**DESIGN/DEVELOPMENT REVIEW COMMISSION  
DESIGN REVIEW DISTRICT  
EVALUATION SHEET  
Informational Presentation**

**ADDRESS:** CanalSide, bordered by Hampton, Williams, Blanding Street, and the City Esplanade

**NATURE OF REQUEST:** Request for Certificate of Design Approval for new construction of four buildings and associated parking

**South Elevation**

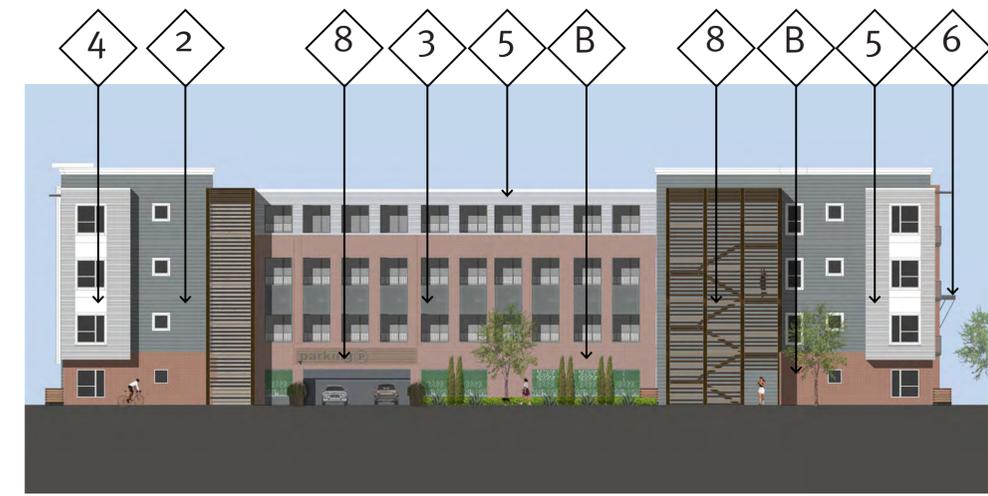
The north and south elevations have smaller percentages on the first floor, due to the residential use.

**03** Detail - Window Head (@ Siding)

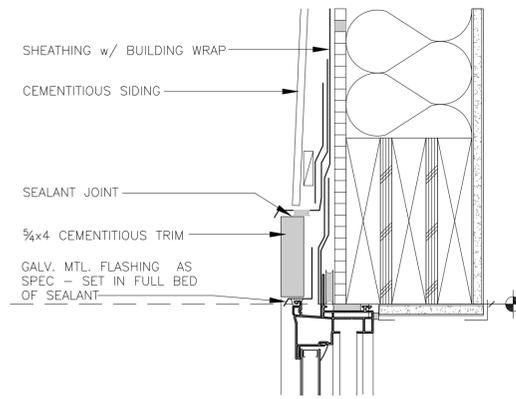
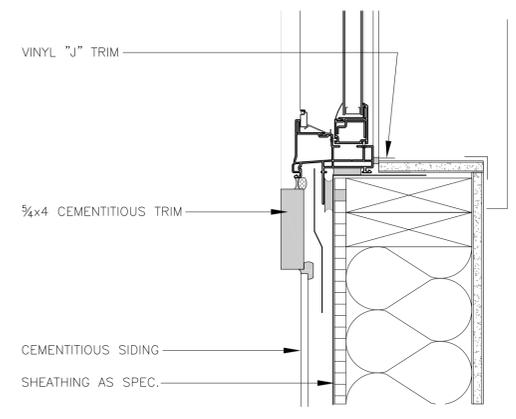
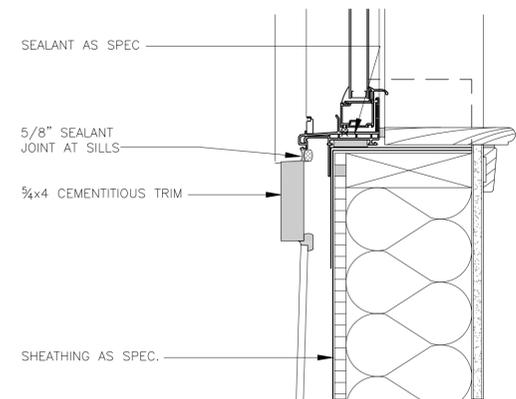
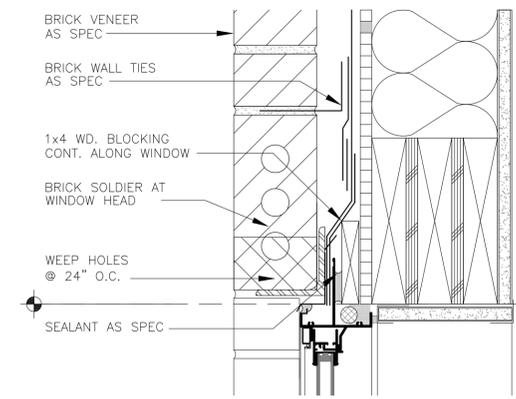
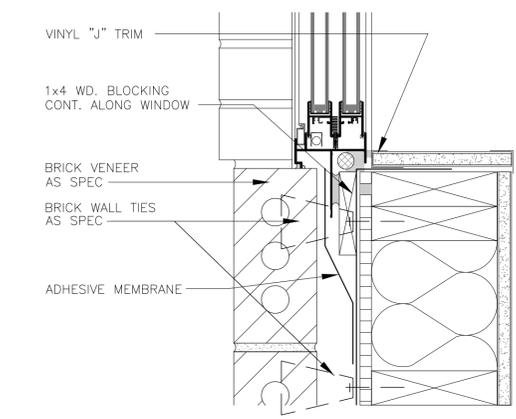
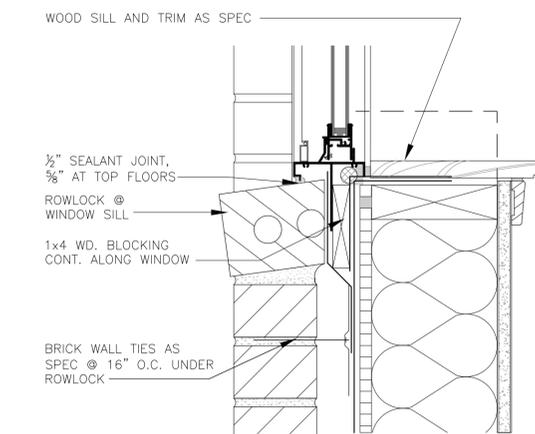
Windows sections have been provided; the window depth at the cementitious panels is shallow, lacking the depth that creates articulation on the façade. The depth of recesses in the brick and metal panels provide more relief. As noted earlier, more information is needed about the depth of materials as they relate to each other.

Windows details have been provided, although without scale or dimensions. The windows at the cementitious siding are relatively flat and so not provide the relief necessary to articulate the upper façade.
